IEEE P802.15 Wireless Personal Area Networks

Project	IEEE P802.15 Working Group for Wireless Personal Area Networks (WPANs)		
Title	Draft running comment resolution		
Date Submitted	[10 January, 2004]		
Source	[James P. K. Gilb] [Appairent Technologies] [16990 Via Tazon, #125, San Diego, CA 92127]	Voice: [858-485-6401] Fax: [858-485-6406] E-mail: [last name at ieee dot org]	
Re:			
Abstract	[This document is a record of comment resolutions for draft DF8 of 802.15.3b.]		
Purpose	[To provide a record of the comment resolutions for draft DF8 of 802.15.3b.]		
Notice	This document has been prepared to assist the IEEE P802.15. It is offered as a basis for discussion and is not binding on the contributing individual(s) or organization(s). The material in this document is subject to change in form and content after further study. The contributor(s) reserve(s) the right to add, amend or withdraw material contained herein.		
Release	The contributor acknowledges and accepts that this contribution becomes the property of IEEE and may be made publicly available by P802.15.

1. Comment resolution in Monterey

Figure 147a—Message sequence chart for a DEV adding an ASIE to the beacon.

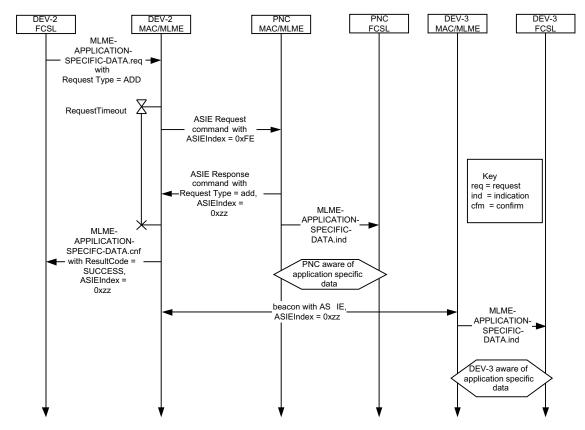
The DEV sends the ASIE Request command with the ASIE Index field set to 0xFE to the PNC to place an ASIE in the beacons, as shown in Figure 147a. The DEV and PNC use the Application Specific ID to identify the ASIE to that its to be added to the beacon. If the PNC allows the request to place the ASIE in the beacon, it shall respond with an ASIE Response command to the originating DEV with the Request Type set to "add", the Application Specific ID set to the same value as in ASIE Request command and the Reason Code set ot "success." If the PNC refuses the request to place the ASIE in the beacon, it shall send an ASIE Response command to the originating DEV with the Request Type set to "add", the Appplication Specific ID set to the same value as in the ASIE Request command and the Reason Code set to the appropriate value,

Figure 147b—Message sequence chart for a DEV removing an ASIE from a beacons

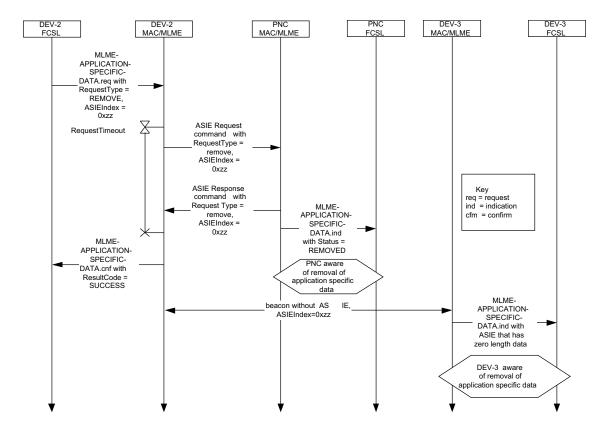
A DEV may also request that the PNC remove the ASIE from the beacon by sending the ASIE Request command to the PNC with the ASIE Index field set to value for the ASIE that is to be removed and a zero length

Application Specific Data field in the ASIE. If the PNC receives this command, it shall no longer place that ASIE in the beacon. This procedure is illustrated in Figure 147b.
